AMENDMENTS TO THE DRAWINGS:

**FIG. 4**

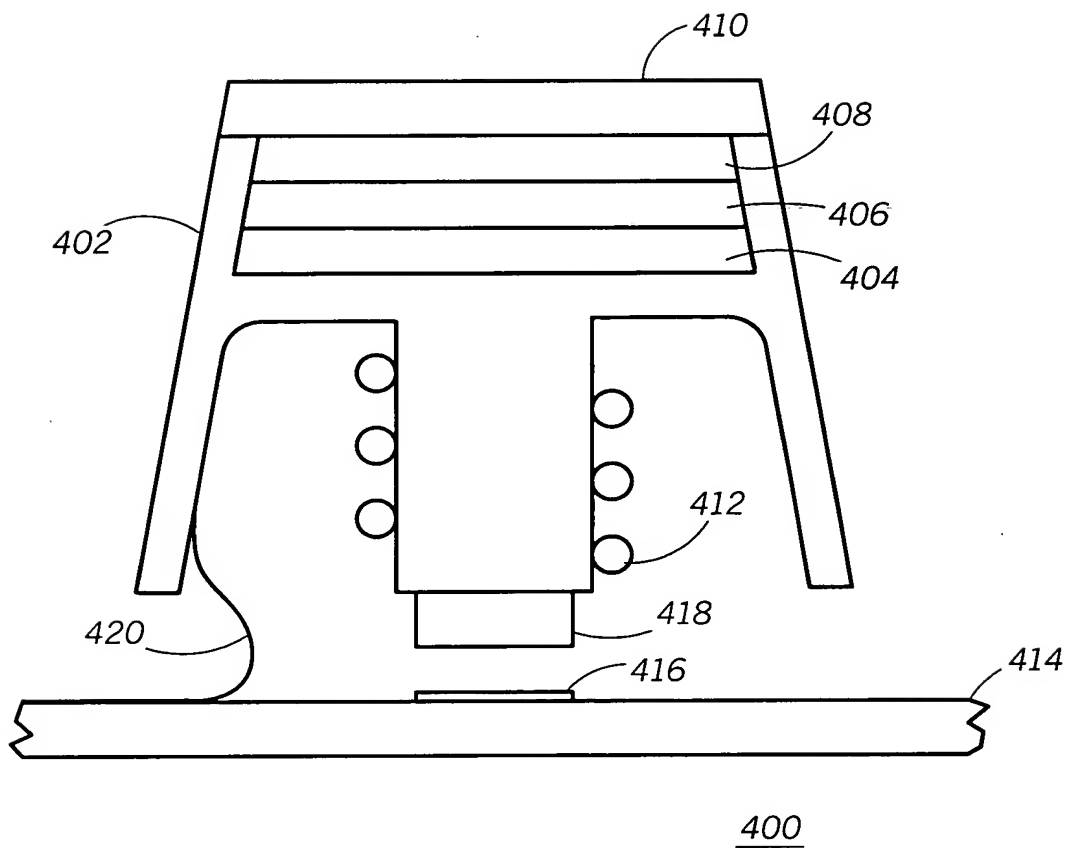
Please note: Drawings were objected to: Corrected drawings are provided herewith; in FIG. 4 the conductive member 418 was erroneously labeled 412. The corrected drawing shows the conductive element as element 418, in accordance with the specification at page 8, line 27.
